CITY PLAN COMMISSION

FILE NUMBER: S245-117

REQUEST: An application to create 3 lots ranging in size from 1.435 acre to 1.998 acre from a 5.557-acre tract of land in City Block 6240 on property located on Lake June Road, west of C.F. Hawn Freeway/ U.S. Highway No. 175 (FKA Second Avenue).

STAFF RECOMMENDATION: The request complies with the requirements of the CS Commercial Service District; therefore, staff recommends approval of the request subject to compliance with the following conditions:

PRELIMINARY PLAT
SUPER FLIES LAKE JUNE
6261 LAKE JUNE ROAD
CITY BLOCK 6240
ALL OF TRACT 13 & PART OF TRACTS 12 & 14
OLD INDIANA PLANTATIONS (UNRECORDED)
5.557 ACRES IN THE VOL. 200203, P.C. 3192
CITY OF DALLAS, DALLAS COUNTY, TEXAS.
CITY PLAT FILE NO. S-245-117
ENGINEERING PLAN NO.

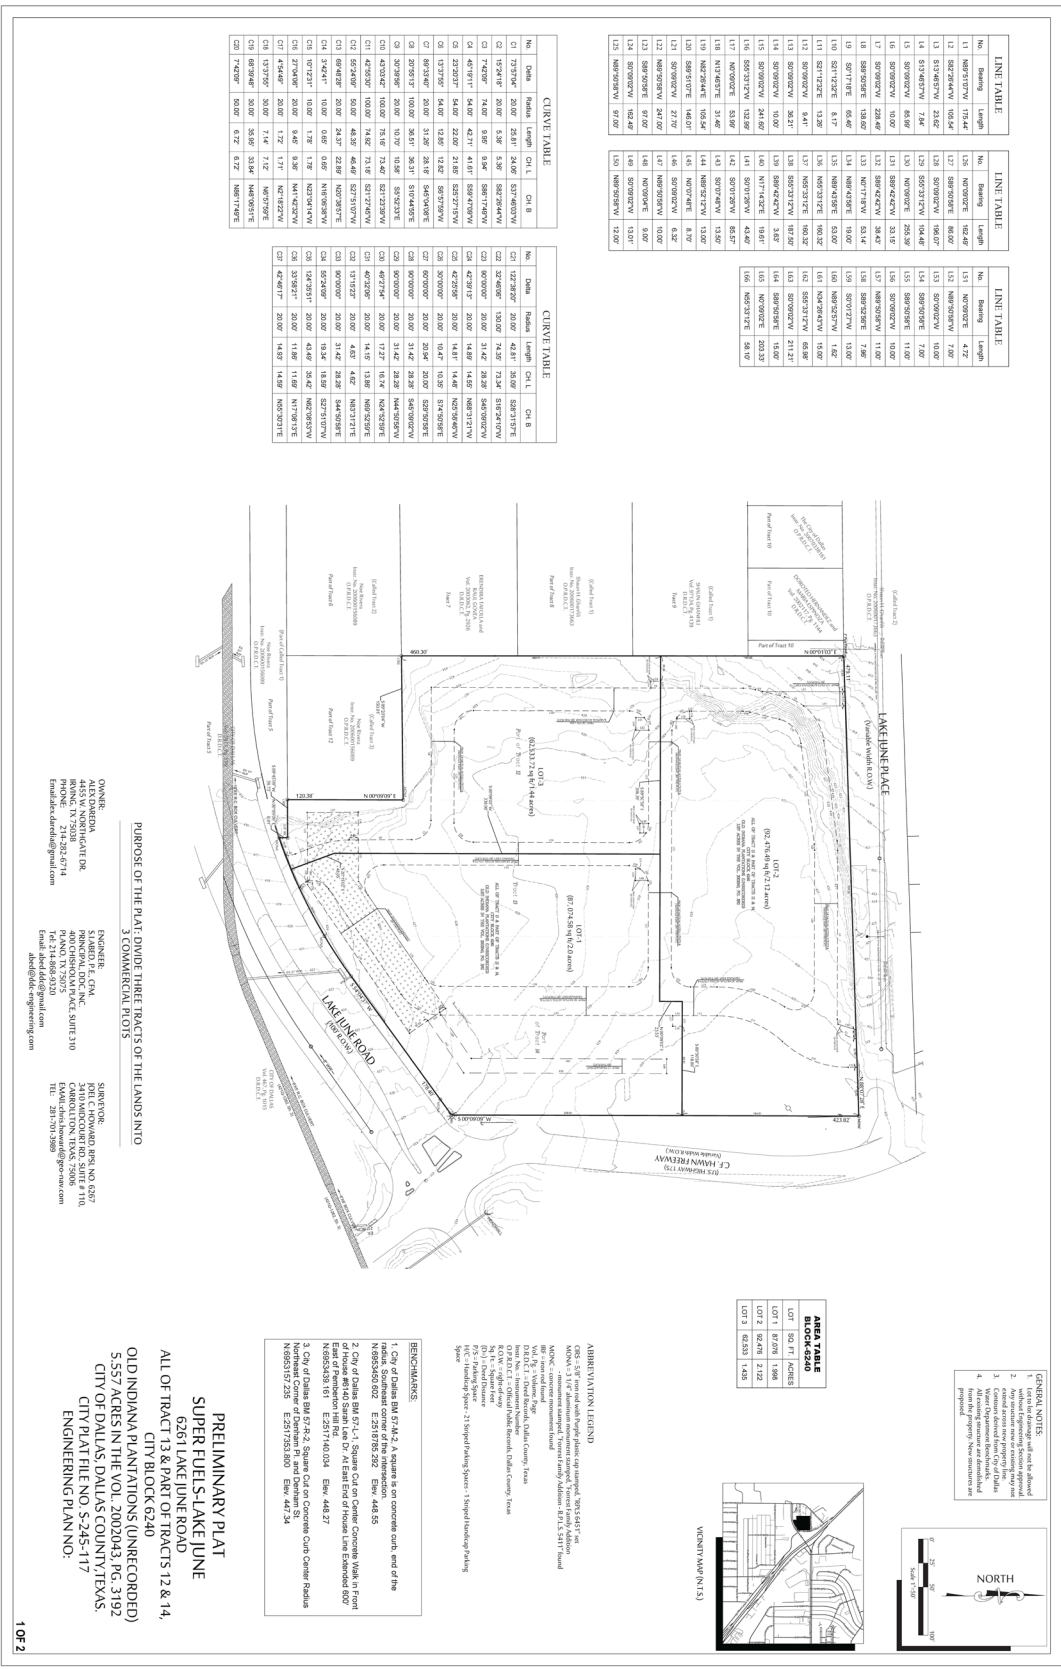
16. On the final plat, dedicate 50 feet of right-of-way (via fee simple) from the established center line of Lake June Road. *Section 51A 8.602(c)*
17. On the final plat, dedicate 28 feet of right-of-way (via fee simple or street easement) from the established centerline of Lake June Place. *Sections 51A-8.602(c), 51A-8.604(c) and 51A-8.611(c).*

18. On the final plat, dedicate a minimum 10-foot by 10-foot corner clip (via fee simple or street easement) at the intersection of Lake June Road and C.F. Hawn Freeway/ U.S. Highway No. 175 (FKA Second Avenue). Section 51A 8.602(d)(1)

19. On the final plat, dedicate a minimum 5-foot by 5-foot corner clip (via fee simple or street easement) at the intersection of Lake June Place and C.F. Hawn Freeway/ U.S. Highway No. 175 (FKA Second Avenue). Section 51A 8.602(d)(1)

31. Engineer must furnish plans for water and sanitary sewer. Developer must furnish a contract for water and sanitary sewer. Sections 49-60(g)(1) and (2) and 49-62(b), (c), and (f).
32. Additional design information is required for assessment. Site plan must be submitted showing proposed development, building finished floor elevation, development, existing mains – including downstream manhole, and proposed water and wastewater service locations. Submit water/wastewater engineering

35. Prior to final plat, compliance with City's Street lighting standards including illumination standards, material, installation, and activation per Street Design Manual.
36. On the final plat, change "(US Highway 175) C. F. Hawn Freeway" to "C.F. Hawn Freeway/ U.S. Highway No. 175 (FKA Second Avenue)".
37. On the final plat, identify the property as Lots 1, 2, and 3 in City Block A/6240.
